Project No. G3422-52-01
March 27, 2025

Subject: INFILTRATION FEASIBILITY CONDITION LETTER
PACIFIC BEACH HOTEL
4545 MISSION BAY DRIVE
SAN DIEGO, CALIFORNIA

Subject: RESPONSE TO CITY COMMENTS
PACIFIC BEACH HOTEL
4545 MISSION BAY DRIVE
SAN DIEGO, CALIFORNIA

FIGURE 1
DATE 03 - 26 - 2025

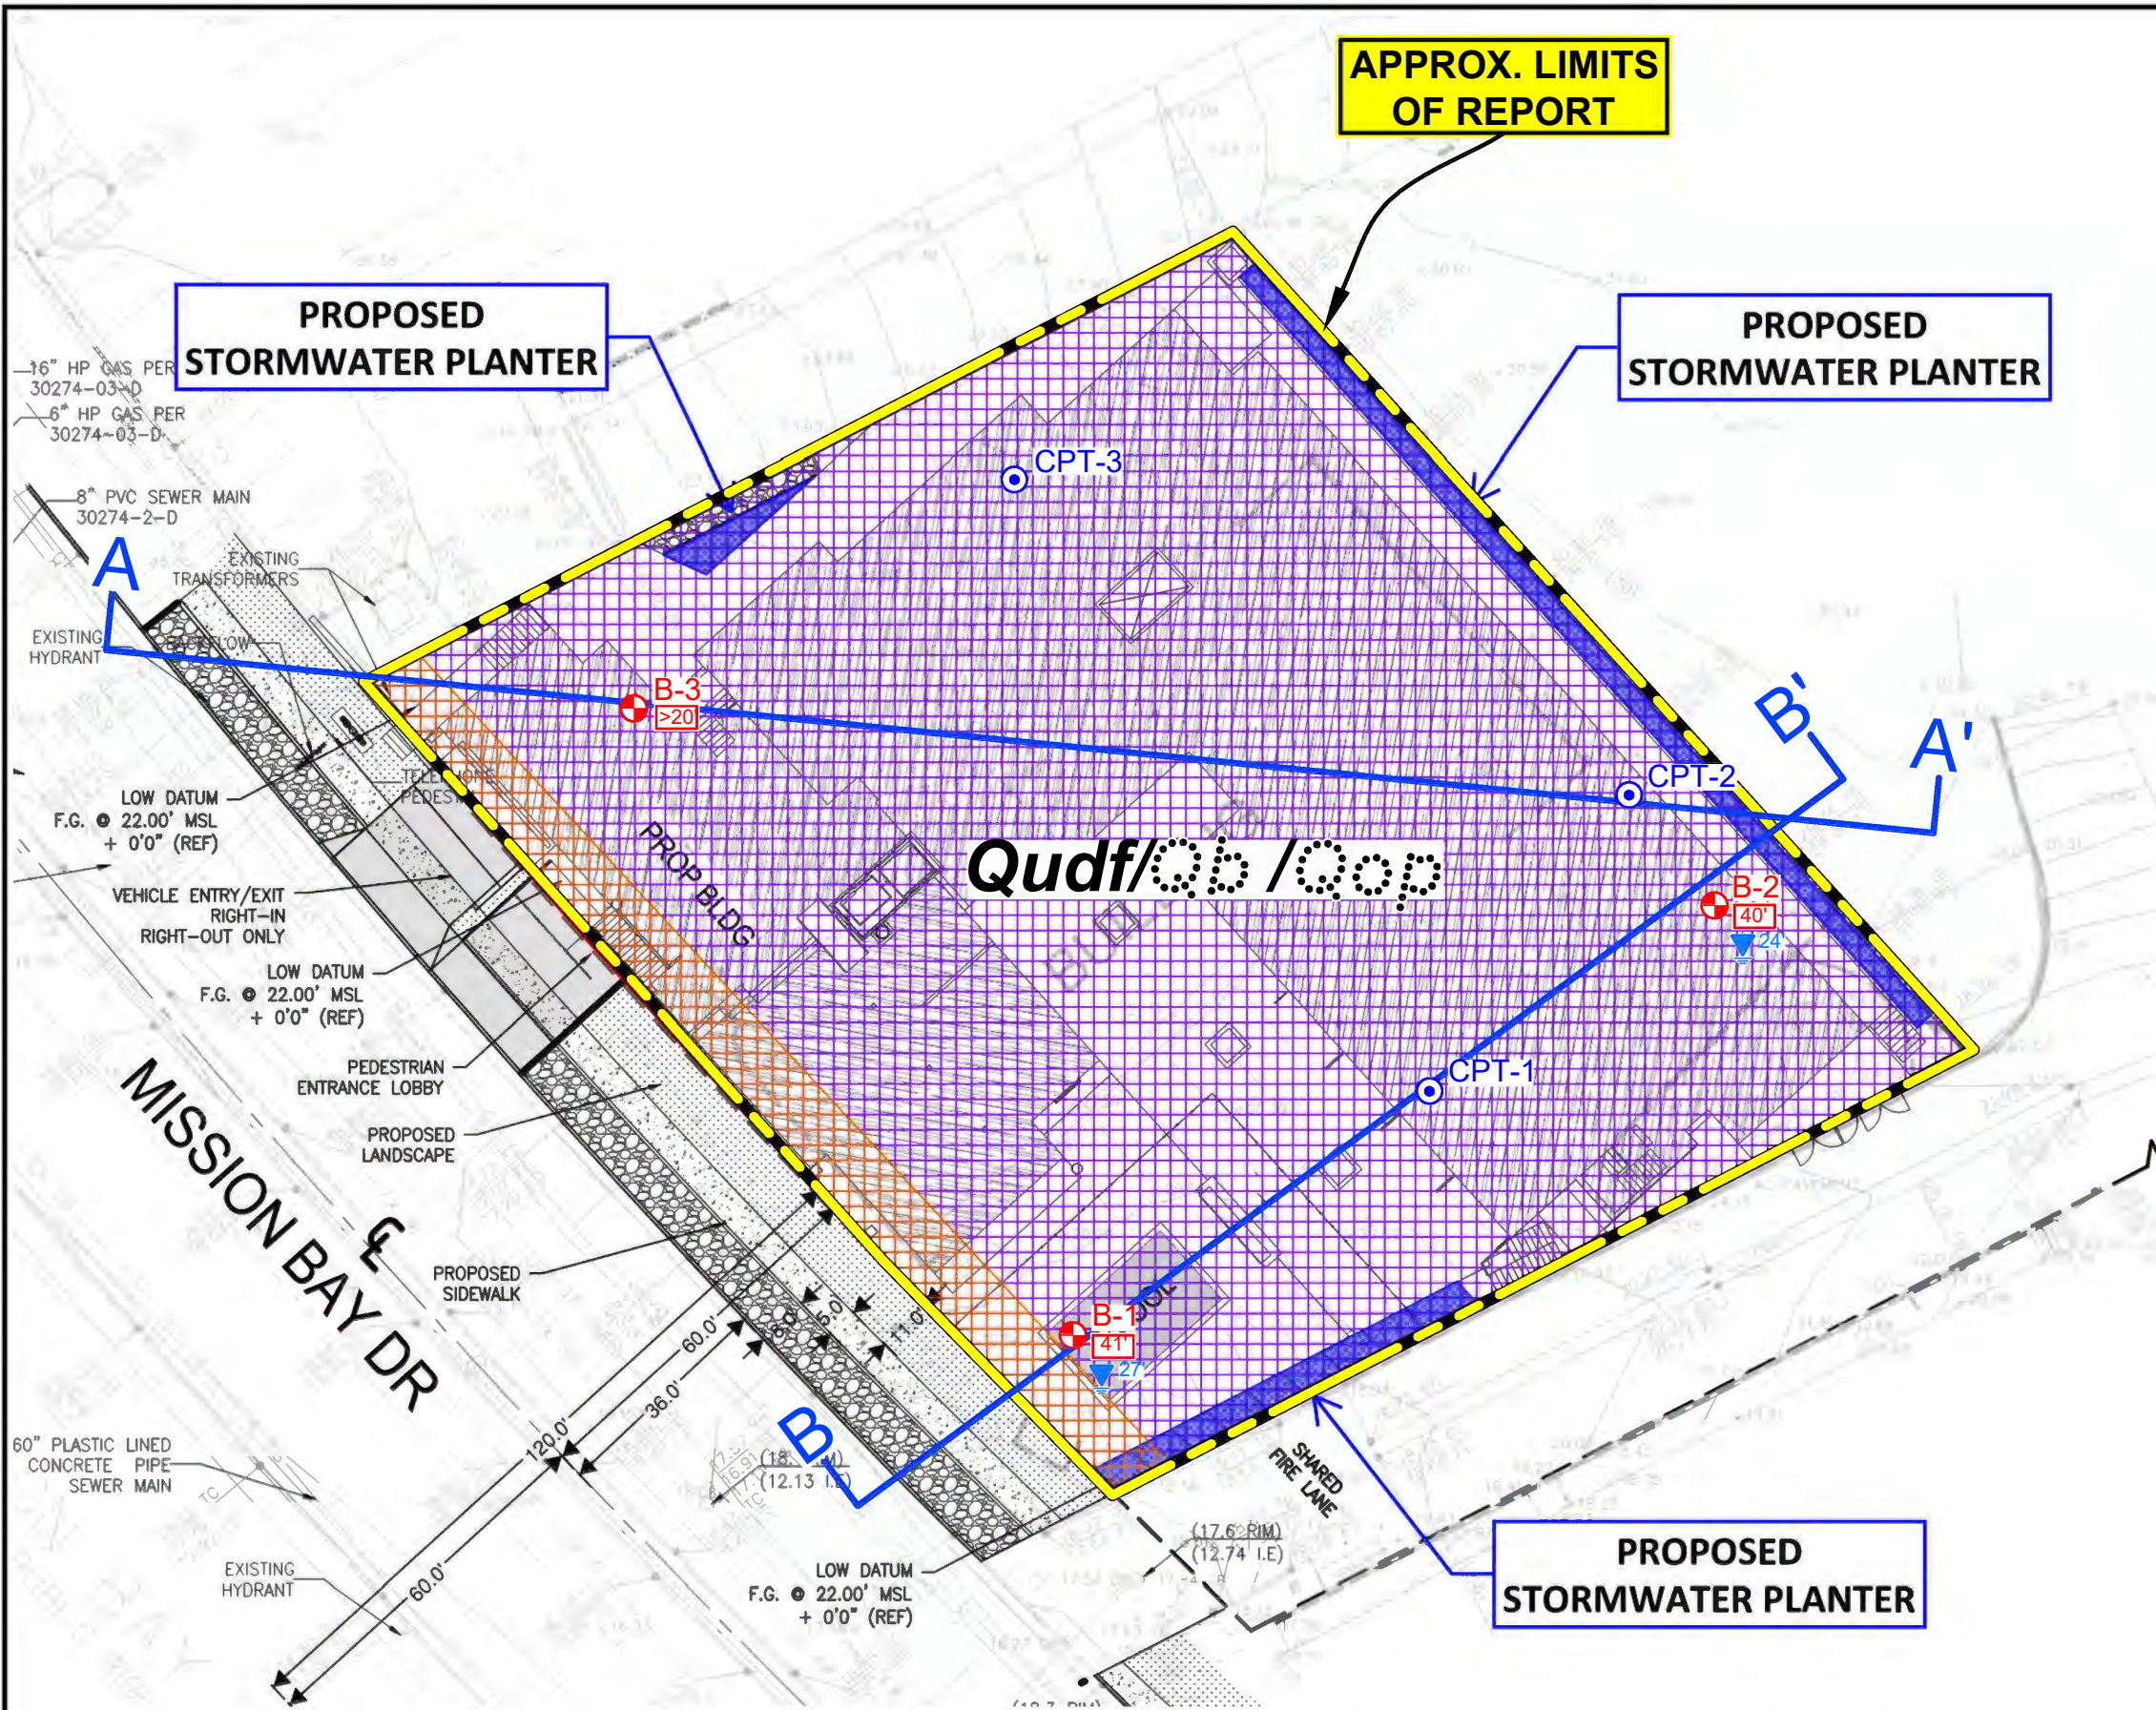
An Exhibit for all applicable DMA’s that clearly labels:

- **Proposed development areas and development type.**
- **All applicable features and setbacks that prevent partial or full infiltration, including underground utilities, structures, retaining walls, fill slopes, natural slopes, and existing fill materials greater than 5 feet.**
- **Potential locations for structural BMPs.**
- **Areas where full/partial infiltration BMPs cannot be proposed.**

from occurring on the subject site and adjacent properties. These standard setbacks are shown on the Stormwater Map, Figure 1.

The Stormwater Map, Figure 1, presents the grading plan as a base map. The figure shows the development area and proposed buildings and improvements. The setbacks are shown on the map that illustrate our opinion that the entire project site is infeasible for infiltration.

GEOLOGIC MAP
FIGURE 1
DATE 03 - 26 - 2025

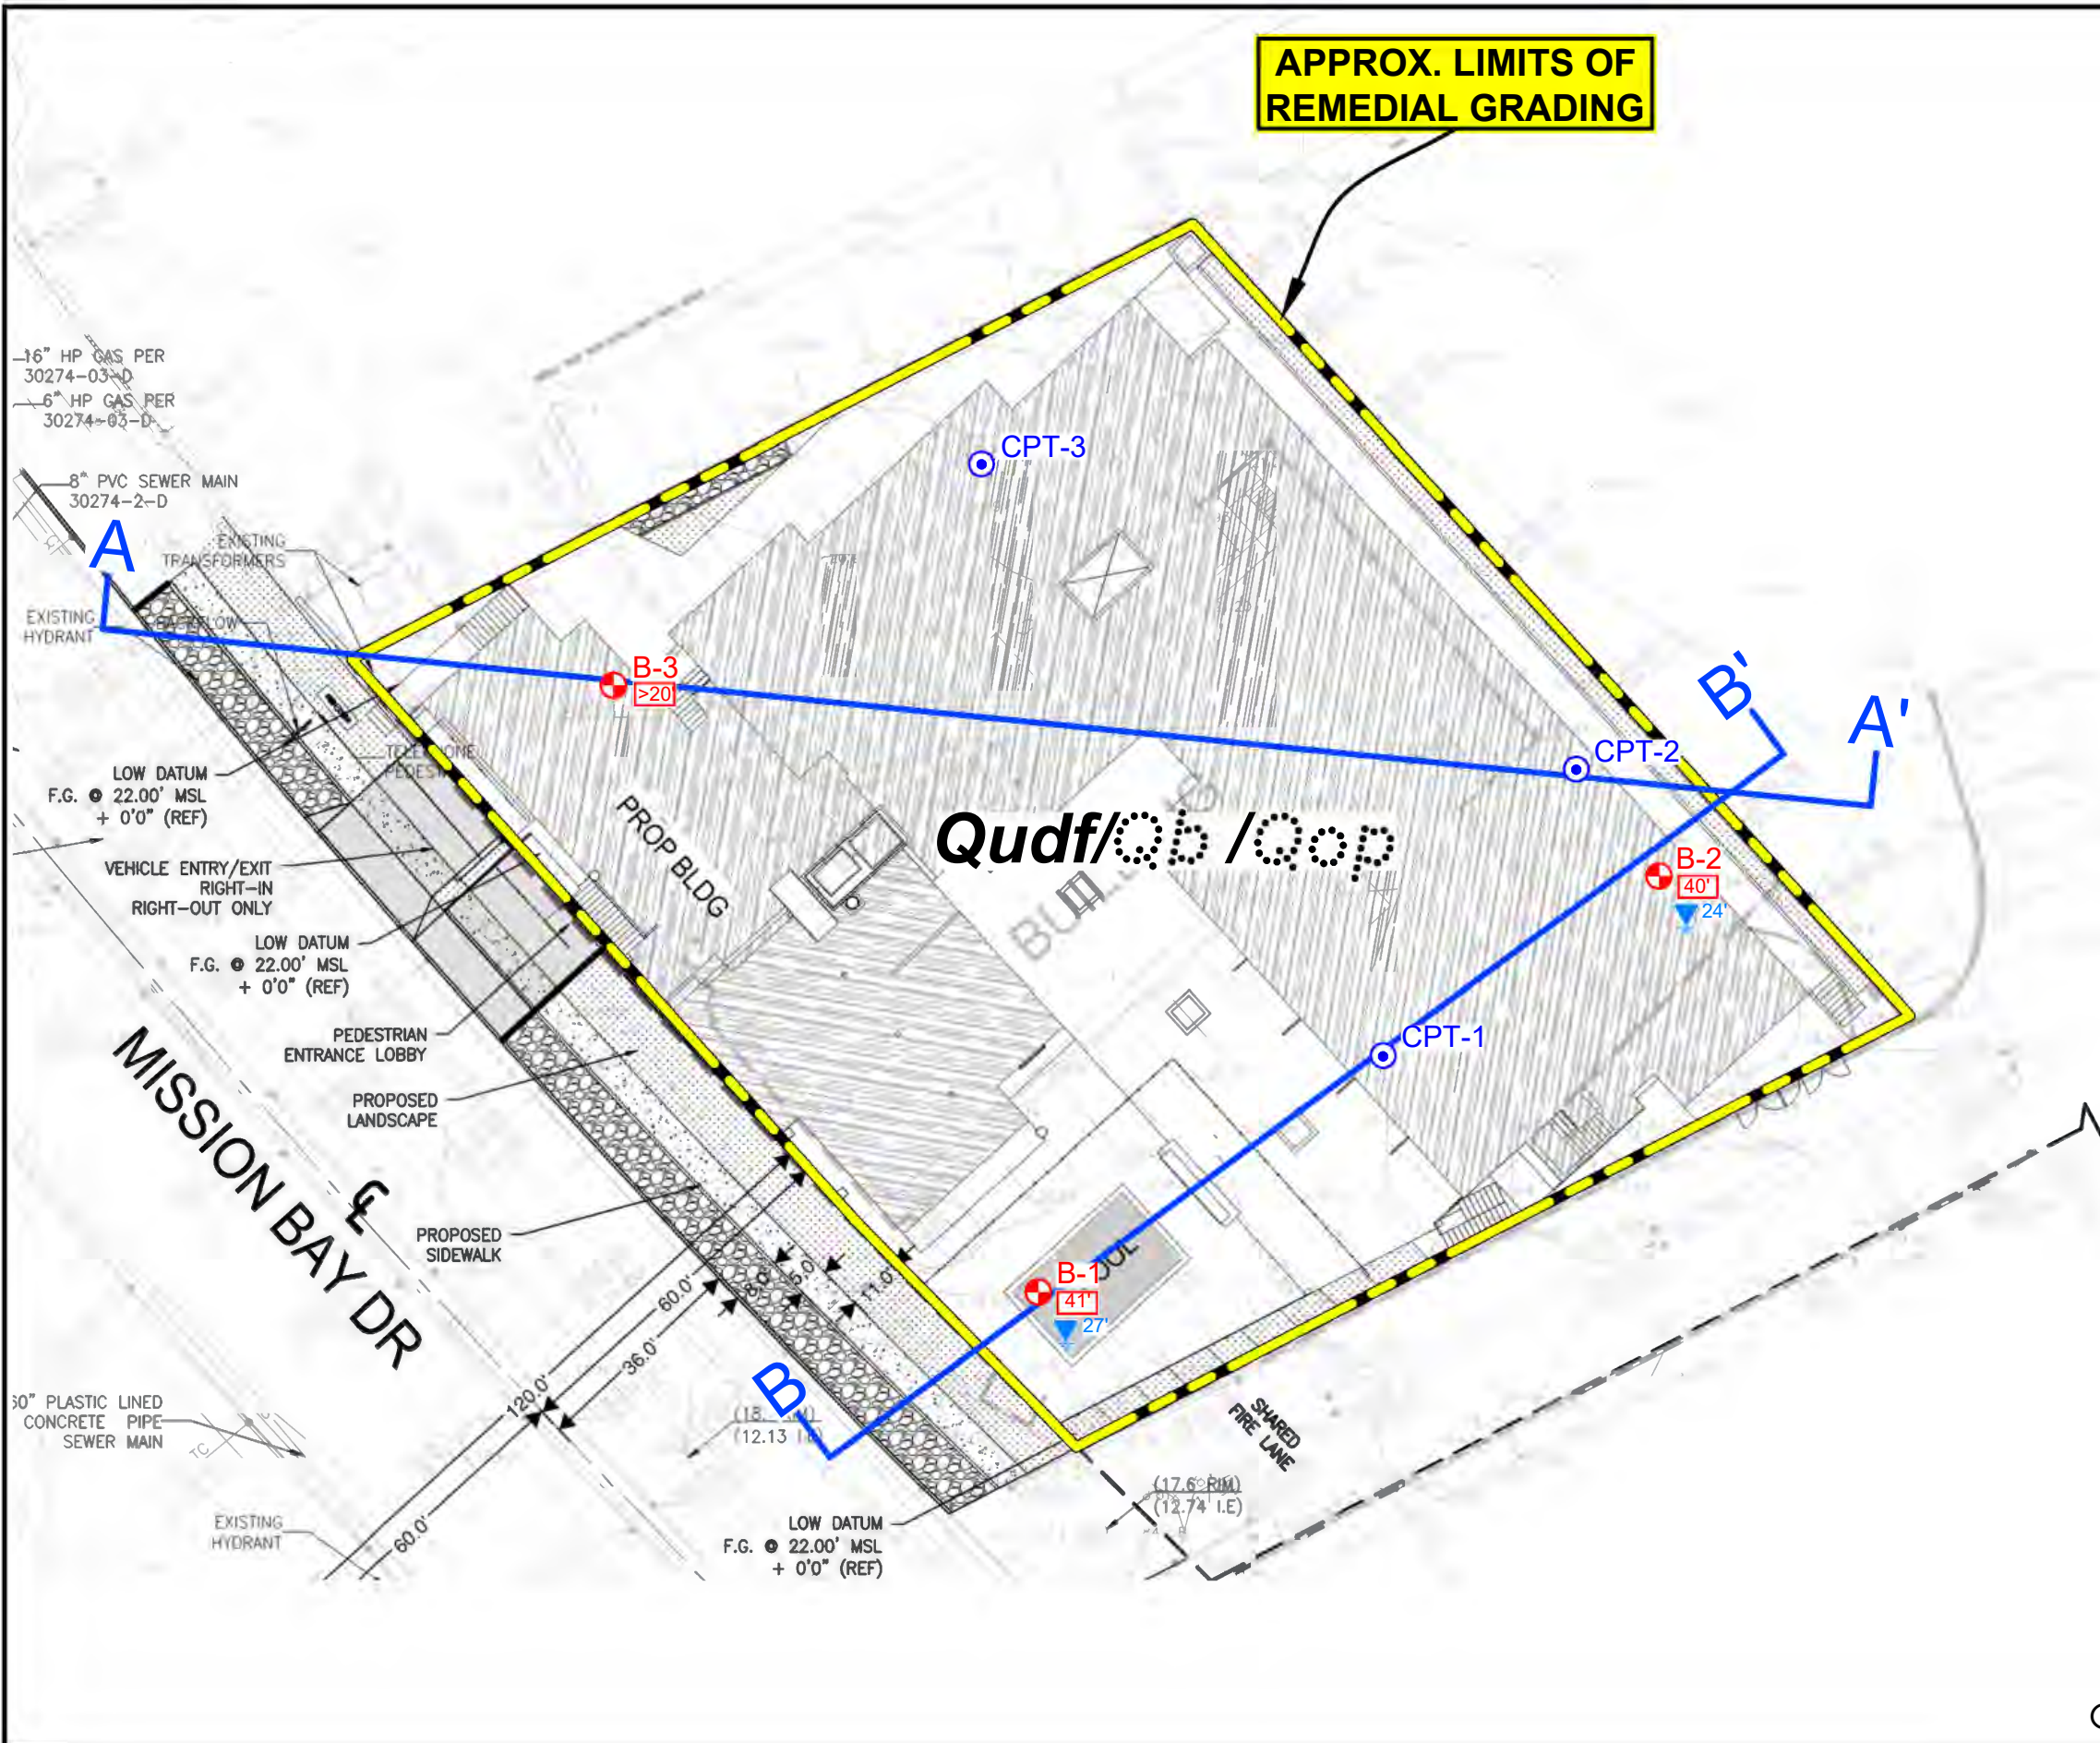
Comment 00005: *If remedial grading is recommended, show the limits of the recommended remedial grading on an updated geologic/geotechnical map.*

Response: Acknowledged. Limits of the recommended remedial grading have been added to our updated geologic map embedded herein.

**APPROX. LIMITS OF
REMEDIAL GRADING**
